Re: Response to Request for Additional Information

This letter provides the information requested by your letter dated June 22, 2010, "Rensselaer Polytechnic Institute, Request for Additional Information Regarding the Renewal of Facility Operating License (TAC No. ME1591)."

Response to Detailed Questions

Figure 1: RCF Management Organization

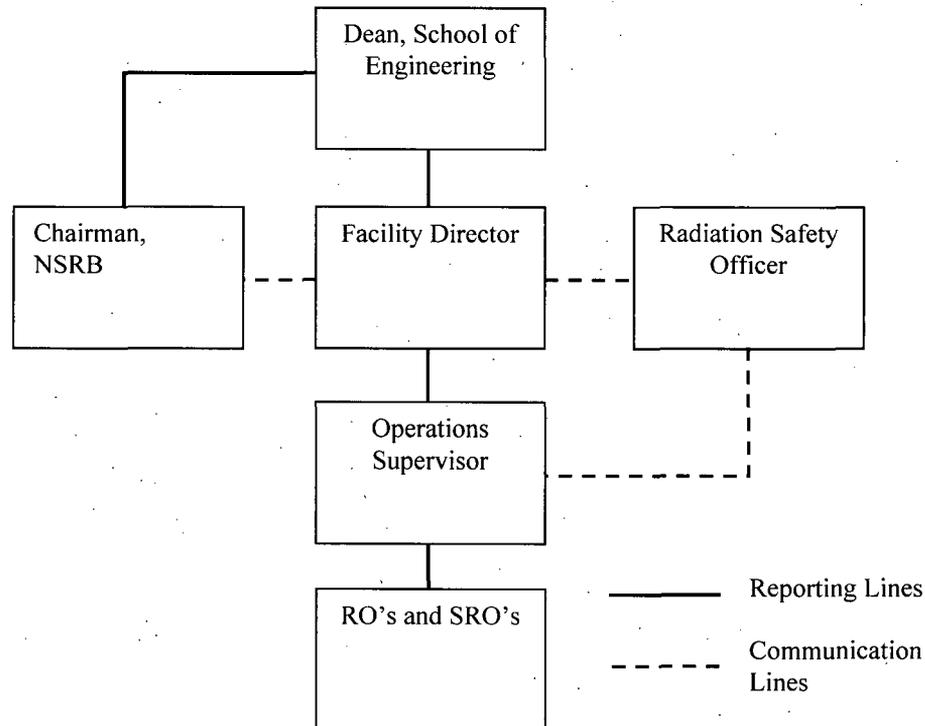
54. Figure 6.1 of proposed TS 6.1 does not indicate any communication lines as recommended in Figure 1 of ANSI/ANS-15.1. Proposed TS 6.1.2 and 6.2 describe communication lines between the Facility Director and the Nuclear Safety Review Board (NSRB) and the RPI Radiation Safety Officer. Revise Figure 6.1 to include communication lines, or justify not including such requirements.

55. Figure 6.1 of proposed TS 6.1 does not include Level 3 and Level 4 of the organizational structure. Revise Figure 6.1 to include Level 3 and Level 4 of the organizational structure, including appropriate reporting and communication lines, or justify not including such requirements.

Response: A new Figure 6.1 was drawn showing reporting and communication lines.

Response: A new Figure 6.1 was drawn showing reporting and communication lines.
